**Re: Lot 10 Block 3 Unit 22 SAD 228
8001 Camino Alderete
Volcano Cliffs Subdivision
Grading & Drainage Plan
Engineer's Stamp dated: 3-8-21 (D10D003R10)
Pad Certification Dated: 3-11-2021**

GRADING AND DRAINAGE PLAN

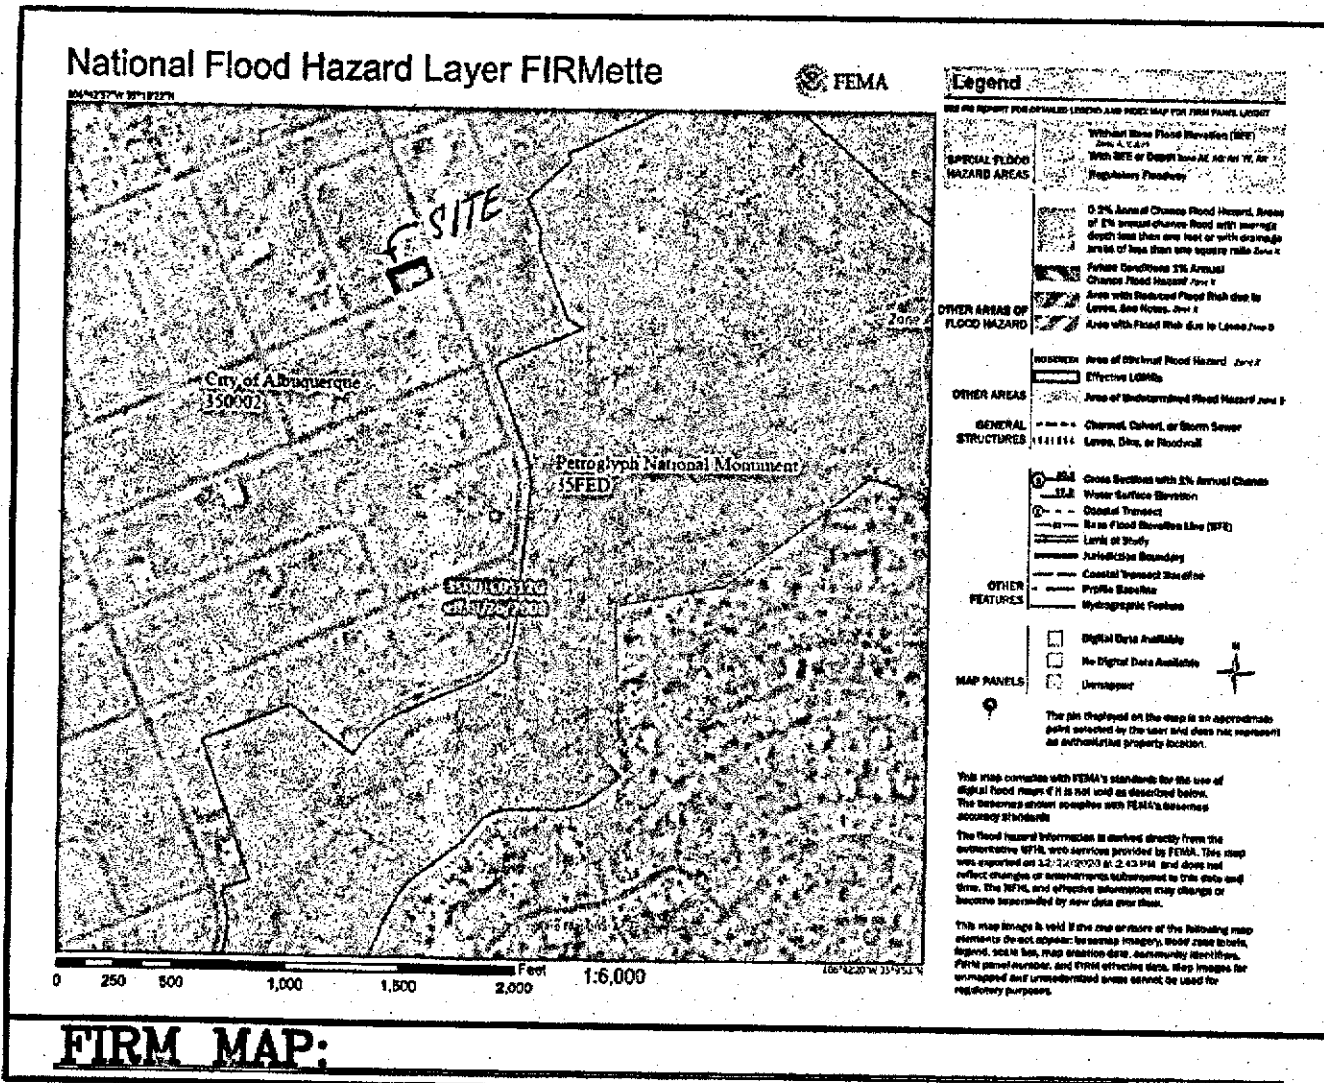
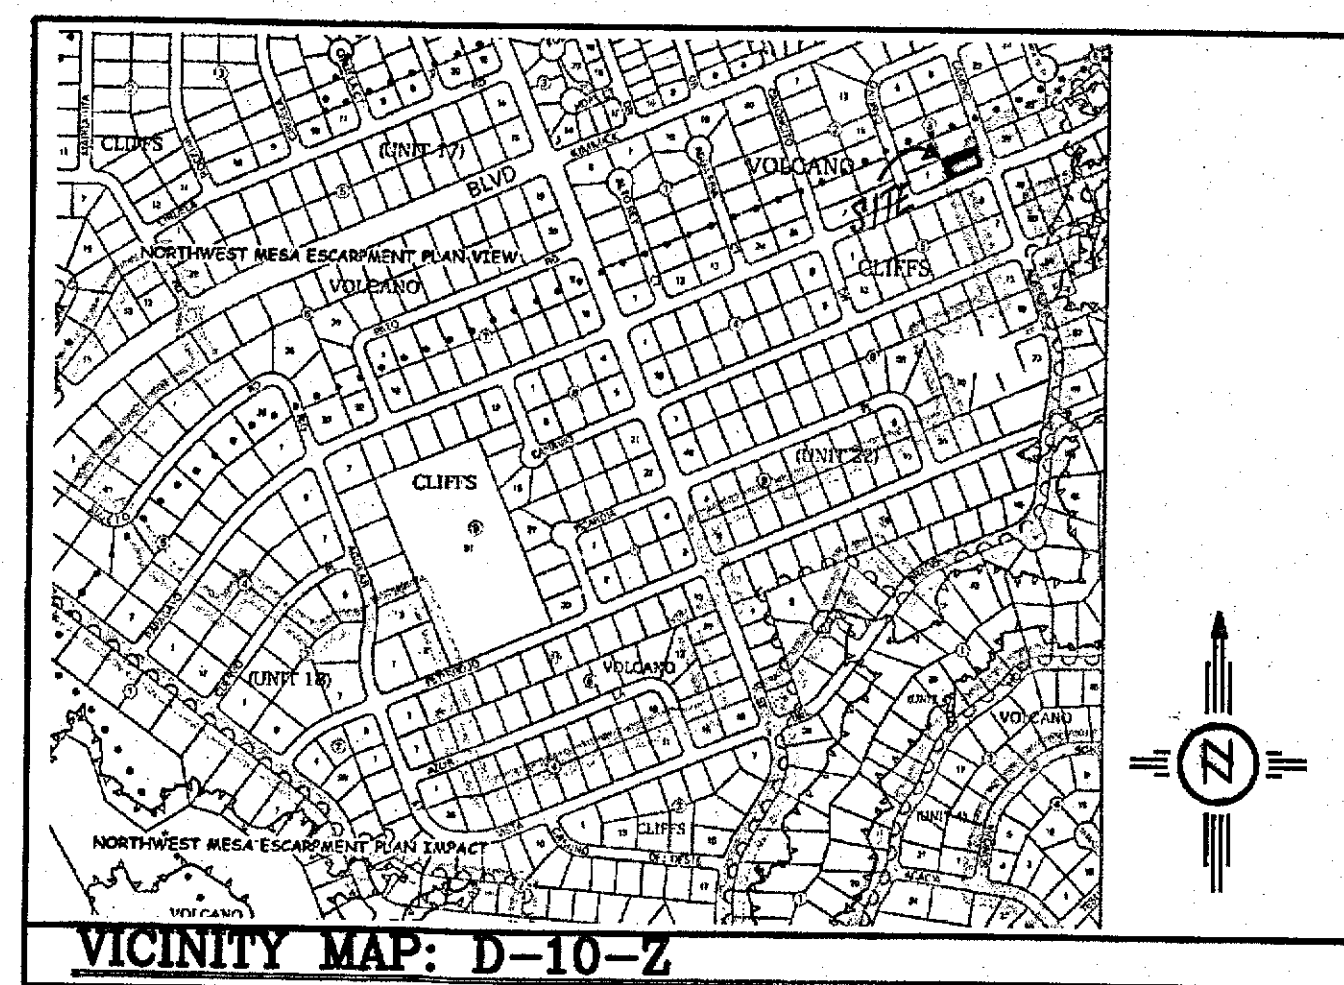
Based upon the information provided in your submittal received 3/11/2021, this plan is approved for Building Permit.

Advise the owner contractor not to use dirt as a ramp to climb the curb, use lumber or crusher fines for this purpose.

Reiterate to the Owner/Contractor that a separate permit for a garden/retaining wall must be obtained, with the approved G&D plan and Pad Certification. Also, let the owner/contractor know that if a pool is to be added in the future the G&D plan will need to be modified showing the location of the pool and the land treatment differences.

Prior to Certificate of Occupancy release, Engineer Certification per the DPM checklist is required.
